Re: Homewood Suites
5400 San Antonio Dr. NE
Request for Certificate of Occupancy
Transportation Development Final Inspection
Engineer's/Architect's Stamp dated 4-11-18 (E15D050)
Certification dated 8-28-19

Based upon the information provided in your submittal received 8-28-19, Transportation Development cannot approve the release of Certificate of Occupancy for the above referenced project.

ARCHITECTURAL SITE PLAN

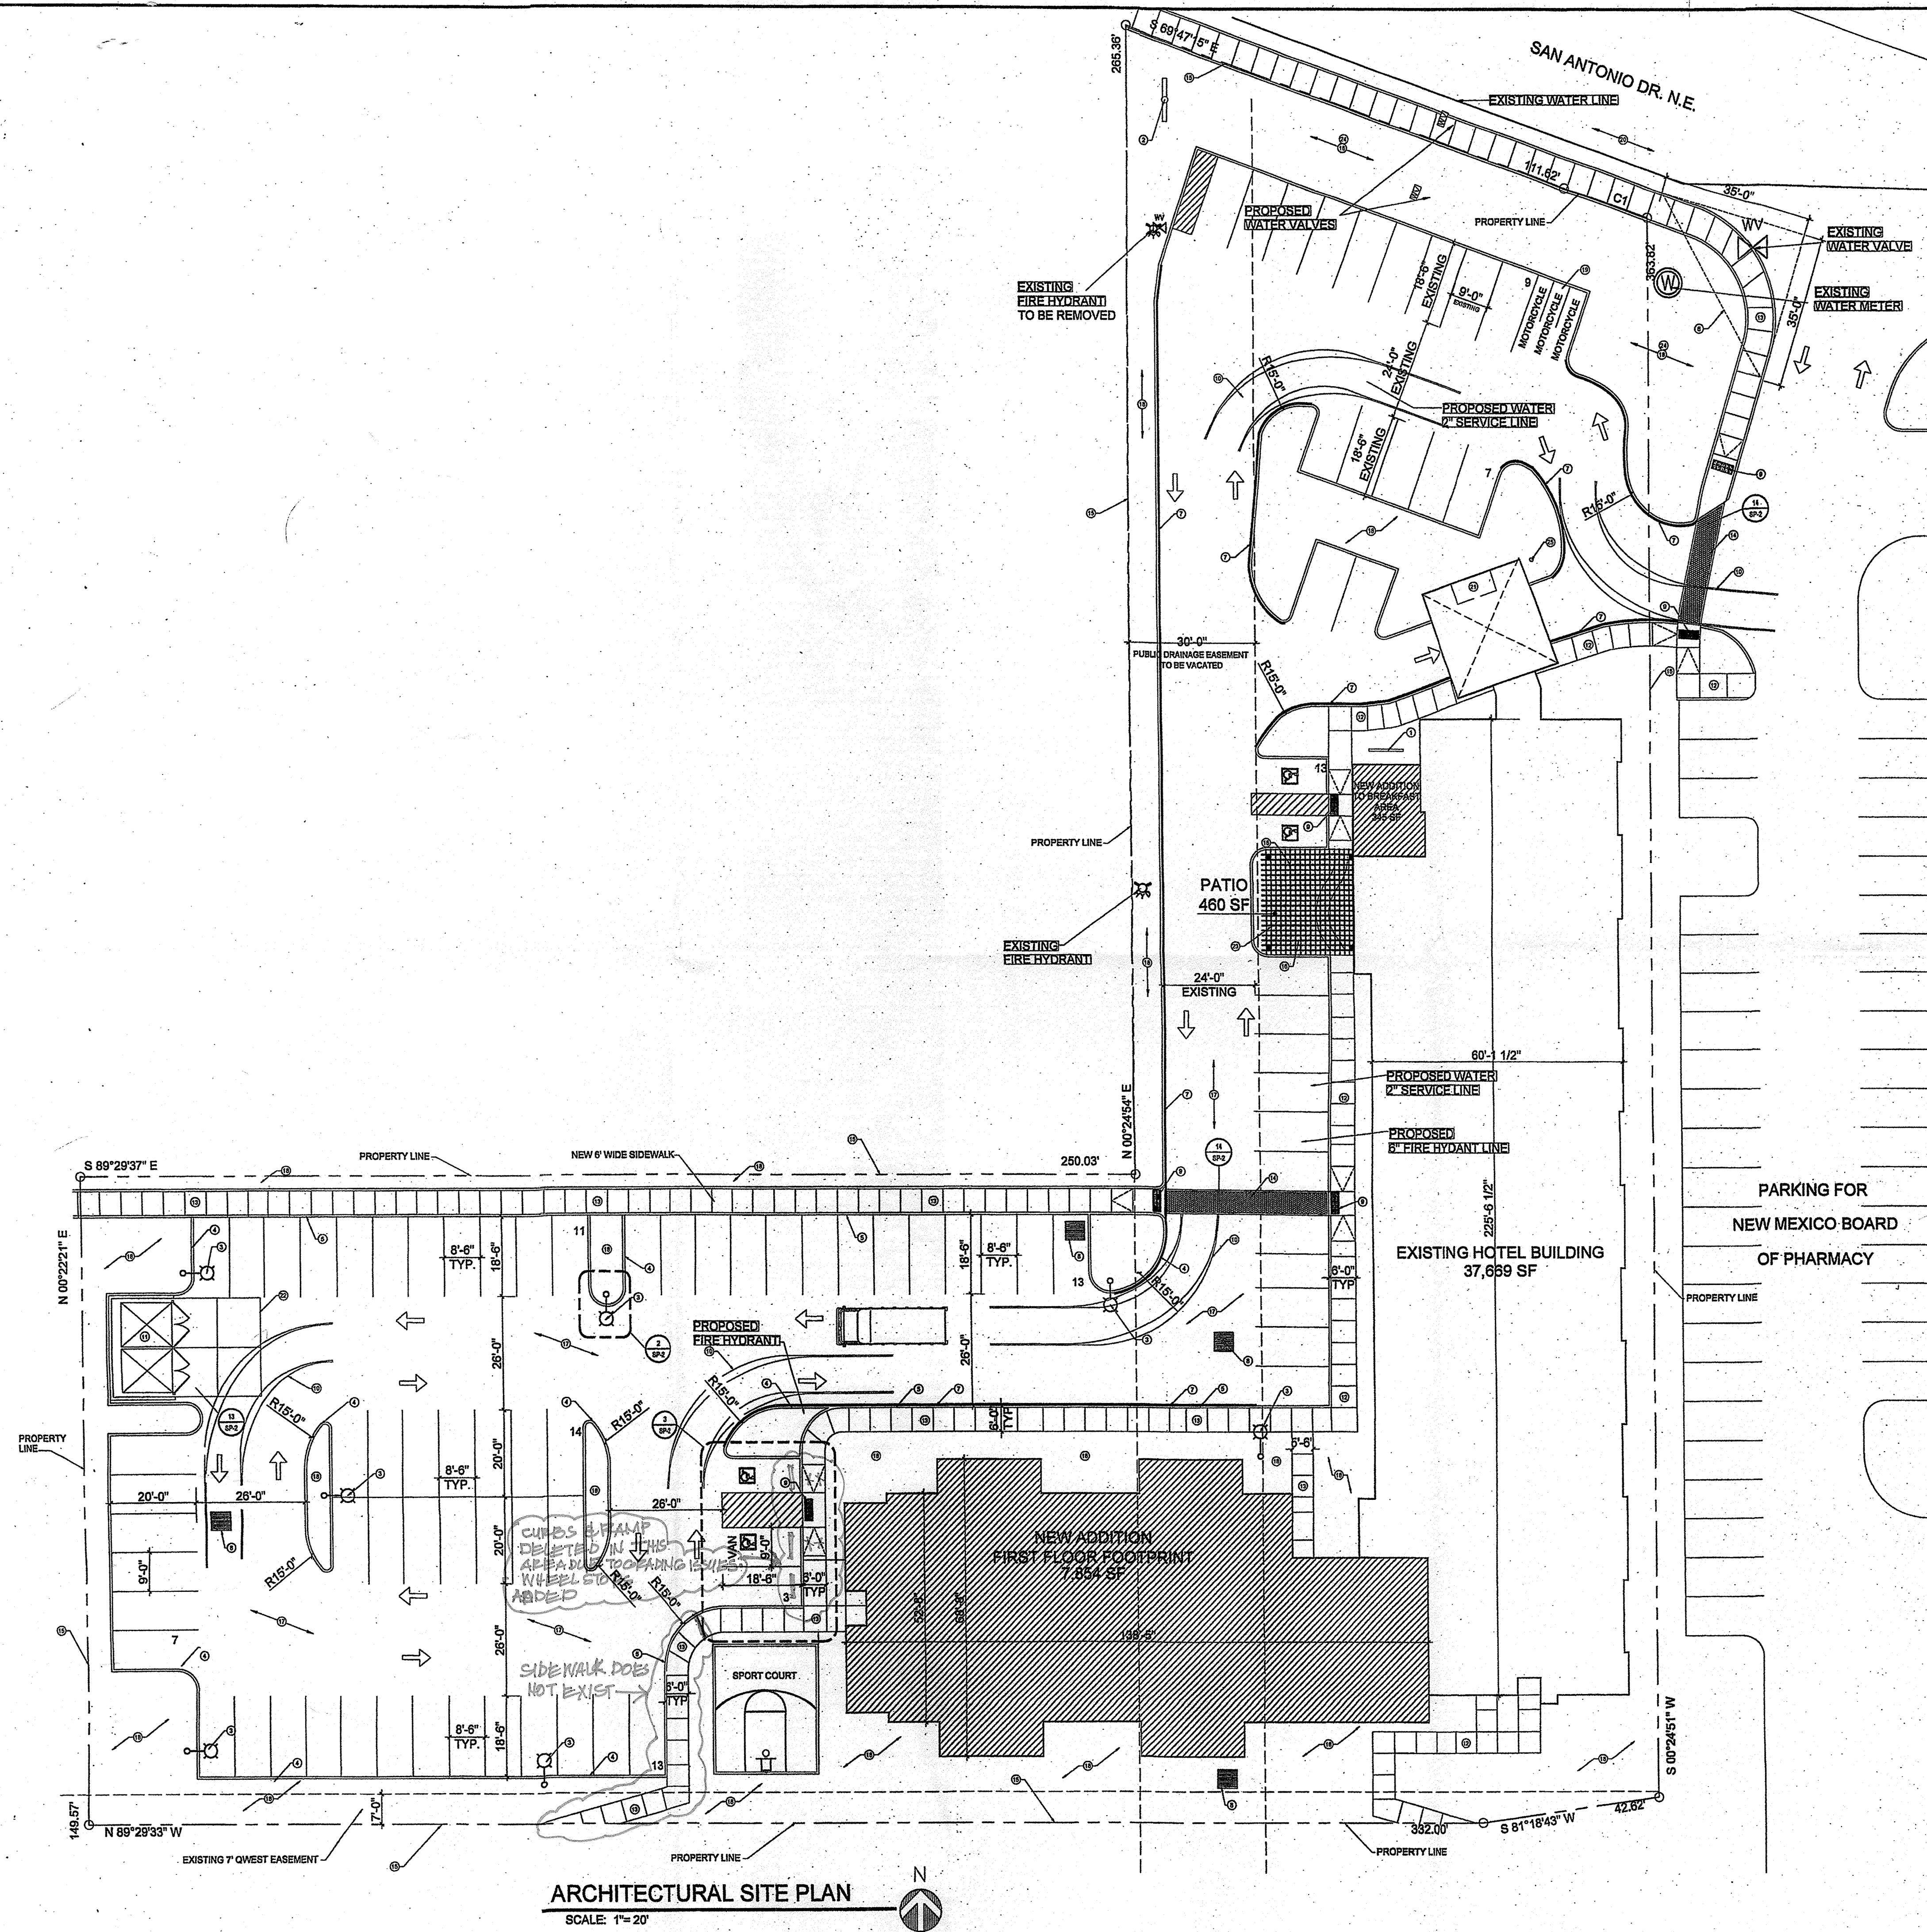
- Add 6ft wide ADA accessible pedestrian pathway from sidewalk to building entrance. Missing ramps and sidewalk. Refer to approved DRB site plan.
- Add missing motorcycle stalls and signs.
- Add missing ADA signs. Stalls located next to Patio.
- Please correct ramp leading to existing building. Ramp has 1" lip not allowing wheelchair access.
- Add sidewalk connecting to path along channel. Refer to approved DRB site Plan.
- Add bollards to parking stall on NW corner. Refer to approved Grading & Drainage Plan. Attach is the section of the Grading Plan indicating the barrier.
- Attached is the DRB Site Plan. Circled in RED are the areas of corrections.

1. The approved and stamped DRB Site Plan for Building Permit with changes drawn in red.
2. Transportation Certification letter on either the plan or applicants letterhead.
3. A Drainage Transportation Information Sheet (DTIS)
4. Send an electronic copy of your submittal to PLNDRS@cabq.gov.
